# SERVICE BULLETIN

EC01-020

## 2001-2002 FRONTIER KA24DE MIL "ON" WITH DTC P0402

**APPLIED VEHICLES:** 2001-2002 Frontier (D22) – with KA24DE Engine**APPLIED DATES:** Vehicles built between May 3, 2001 and July 12, 2001

Figure 2

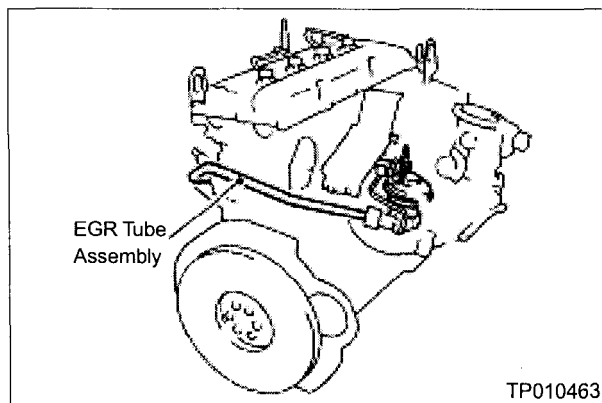
4. Compare the vehicle's ECM P/N to those shown under **Current ECM P/N** in Chart A on page 1.
  - A. If the ECM P/N in the vehicle matches the number listed under "Current ECM P/N" in Chart A, proceed to Step 5 below.
  - B. If the ECM P/N in the vehicle does not match the number listed under "Current ECM Data P/N" in Chart A, this bulletin does not apply. Use the appropriate Electronic Service Manual (ESM) to further diagnose and repair the incident.
5. Remove the EGR Tube Assembly and install the EGR Tube Assembly listed in the PARTS INFORMATION section below (see Figure 2 for location of EGR Tube Assembly).

DESCRIPTION	PART NUMBER	QUANTITY
Tube Assembly – EGR	14725-F4506	1
